Navion Service Bulletin No. 108R1

Subject: Cabin Air Valve Housing Support:

Models Affected: All Navions, Serial Numbers NAV-4-002 through NAV-4-2561 models D, E, F, G and H with engines installed under Navion drawings 161-30001 or 147-30001 **OR** any Navion modified per type certificate data sheet A-782 items 139, 140, 141, 142 with 145-42122-SA11 Cabin Air Valve Housing and external power receptacle installed on right hand cowling area (Fuselage Station 46).

Figure 4. Original Drawing Section

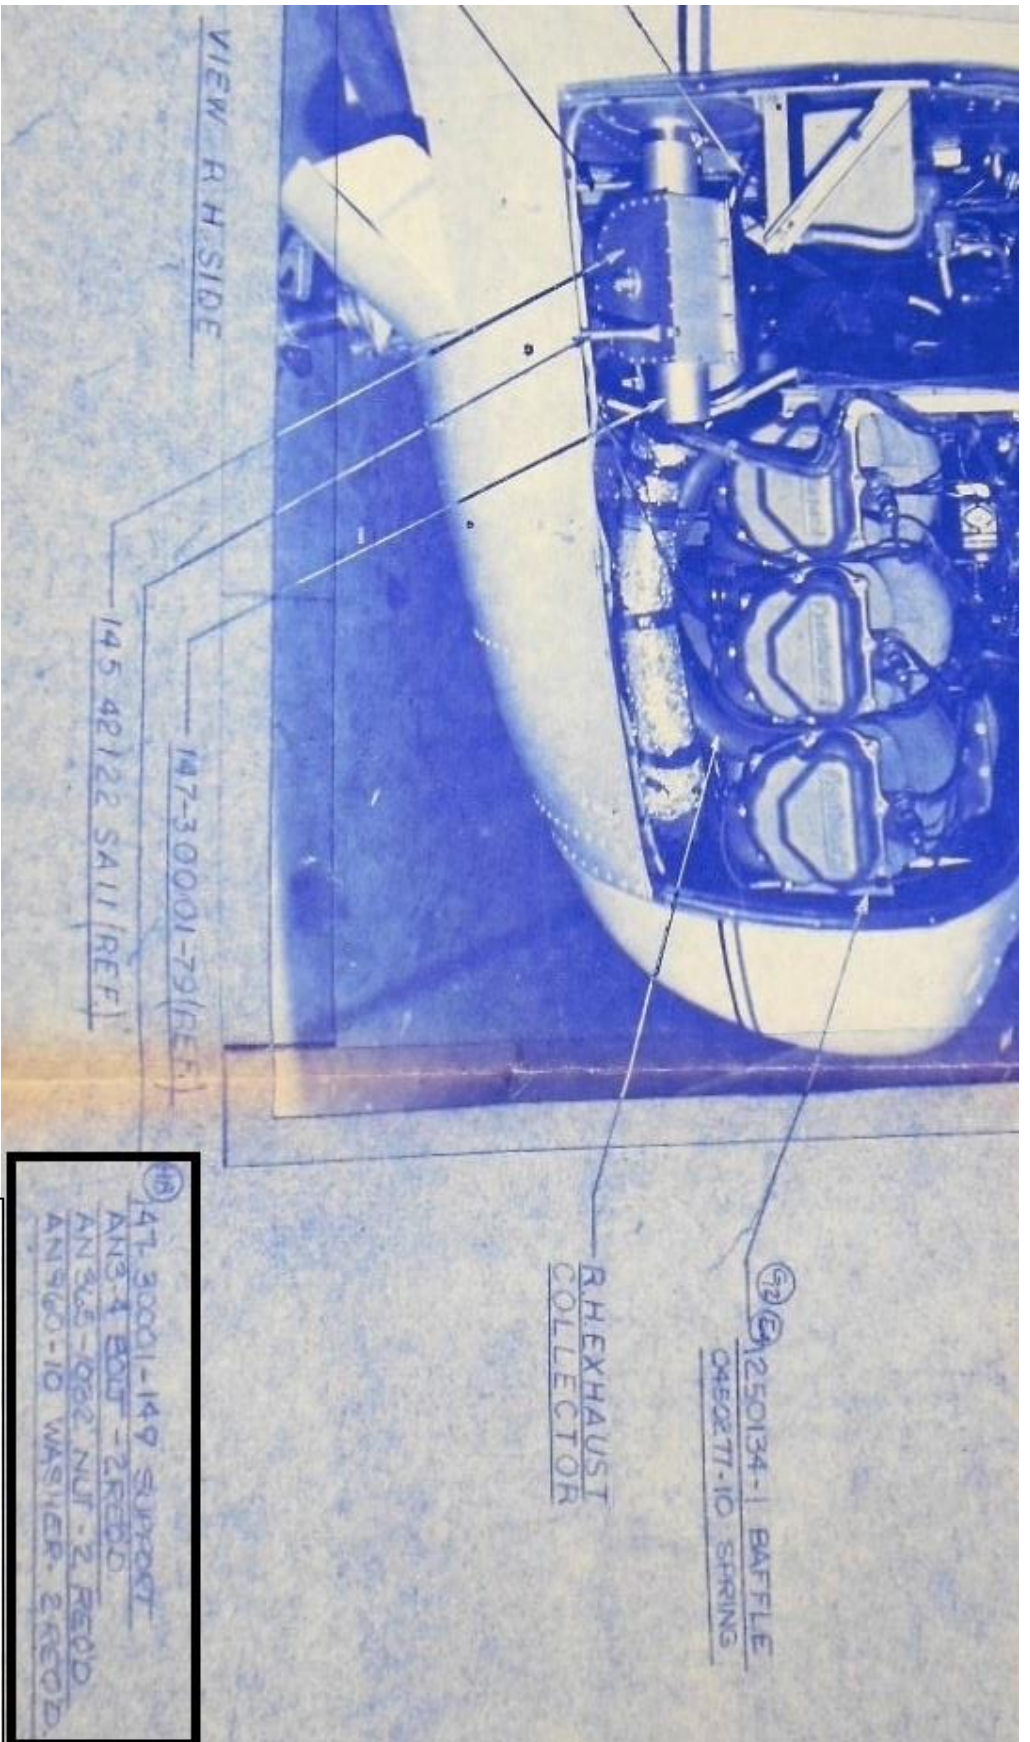
Action: Before further flight, open right side cowling and verify the installation of support bracket (Part No.147-30001-149). Reference Figure (1), Figure (2), Figure (3) and Figure (4) on subsequent pages. Install support bracket if support bracket is missing. If ground power plug is installed, check clearance between heater box and terminals. If rubber boots on terminal are missing or damaged, replace Part No.MS25171 or equivalent. Please contact SHA technical support for assistance on obtaining these parts.

Text in black box reads:
 147-30001-149 SUPPORT
 AN3-4 BOLT - 2 REQ'D
 AN365-1032 NUT - 2 REQ'D
 AN960-10 WASHER - 2 REQ'D
